LIME DOWN SOLAR PROJECT

**DEADLINE 6 SUBMISSIONS
STOP LIME DOWN**

August 2026

Fig.3.1 Cumulative avoided emissions during operational cycle for fixed value of 48.9gCO₂e/kWh (Grid intensity in 2029)

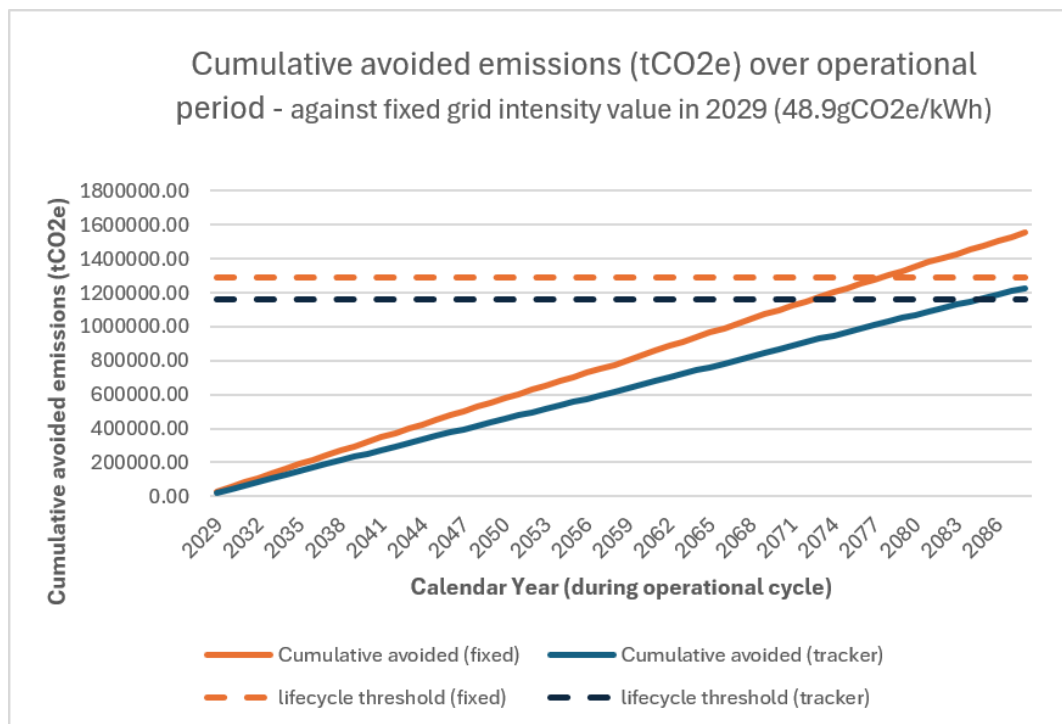
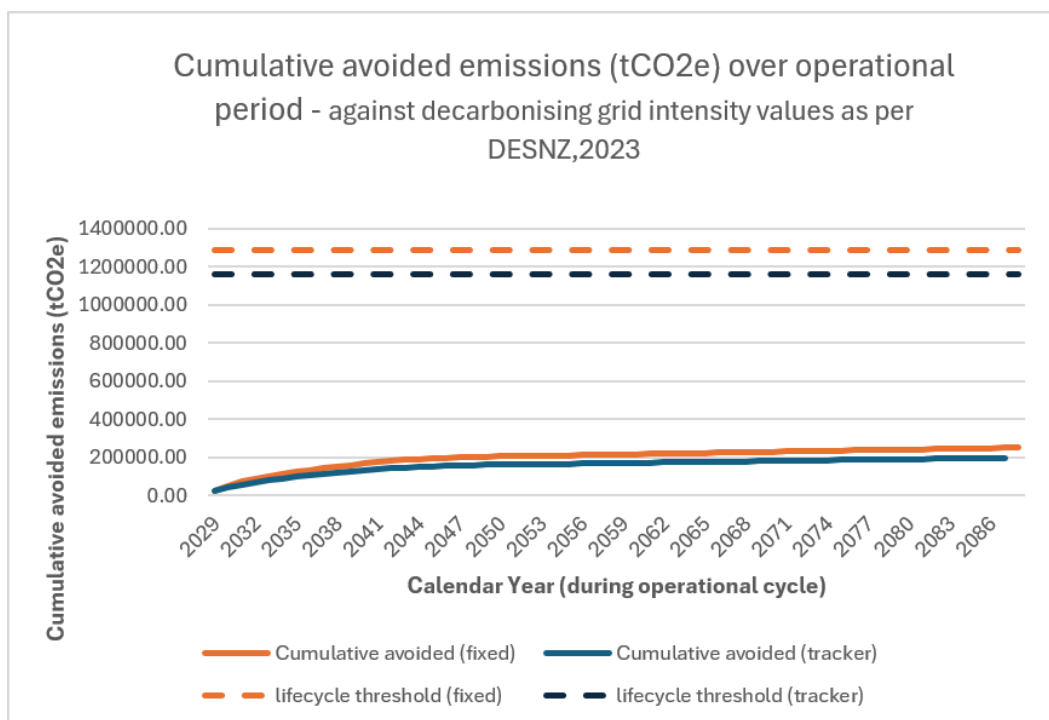
Figures 3.1 and 3.2 show the two contrasting approaches. Cumulative avoided emissions (i.e. those which would be produced by the grid for the same electricity generation of the Scheme) are compared with the incurred emissions of the Scheme (the two different thresholds represent the two panel scenarios: fixed and tracker). In the Applicant's approach (Fig 3.1) payback occurs along with the quoted net savings. The cumulative avoided emissions crosses the Applicant's given lifetime GHG emissions threshold of **1,286,483 and 1,160,670 tCO₂e** for fixed and trackers respectively. On the other hand, in the UoD's approach (Fig 3.2), payback does not occur.

Evidently, these almost represent two extremes, and it is likely the true answer lies somewhere between. Using the same rationale in the Appendix spreadsheet, it is possible to calculate the net savings using comparisons made using different Grid intensities to demonstrate this point (3.1)
